**TULSA METROPOLITAN AREA PLANNING COMMISSION**  
Minutes of Meeting No. 1585  
Wednesday, December 18, 1985, 1:30 p.m.  
City Commission Room, Plaza Level, Tulsa Civic Center

DeShazo, Starek & Tang, Inc.  
Engineers • Planners

RESOURCE SCIENCES CENTER PARK  
FIGURE 8 IMPROVEMENTS

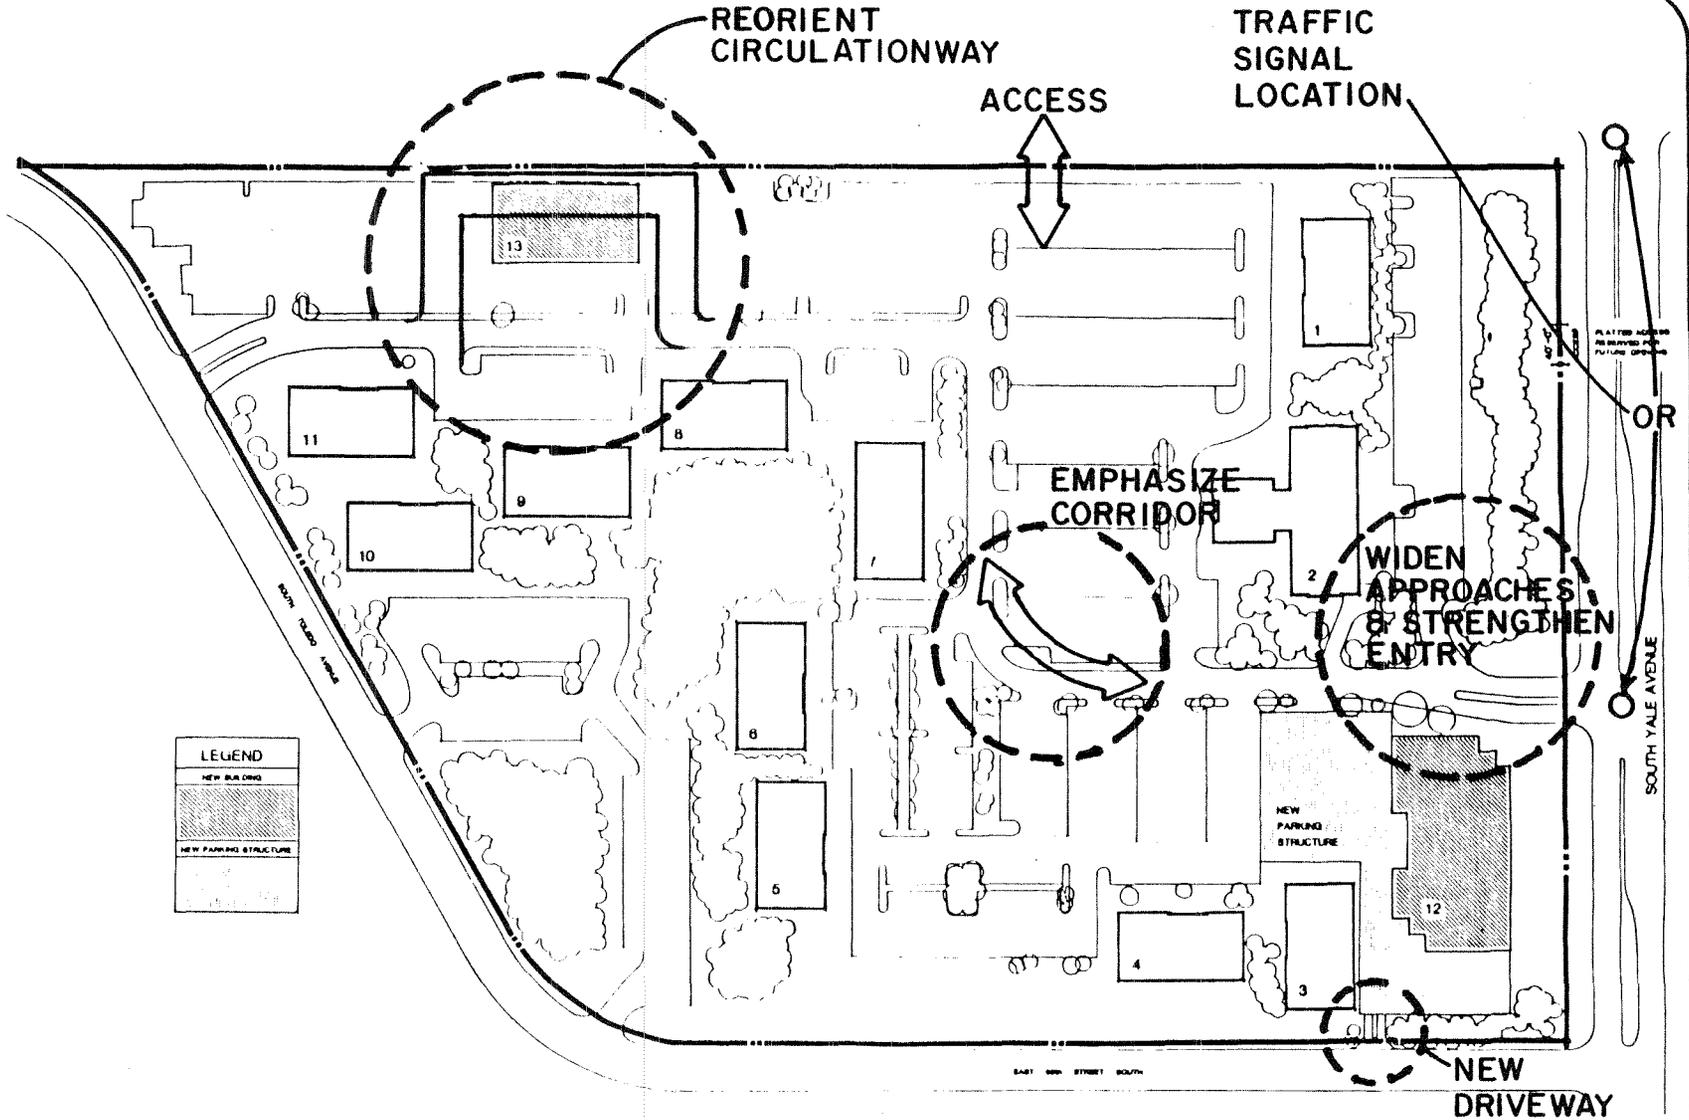
However, to minimize the impacts of the two new buildings and the existing development on the nearby neighborhood, modifications should be made to the RSC site. The primary need for the site is to orient and make convenient the movement of traffic to Yale. The best method to increase the traffic orientation toward Yale would be to locate a traffic signal at the main entrance of RSC.

objective and also serve a collector street (66th Street) to the east although RSC would have to obtain access through the Shell tract. The potential traffic signal locations are shown on Figure 8.

Further traffic improvements can be achieved by changes in the main internal roadway will further minimize impacts on the adjacent collector streets. See Figure 8. The internal drive should be routed around the new low-rise building to "break-up" the straight through movement to the west. In the main surface parking areas, the internal roadway should direct vehicles toward Yale.
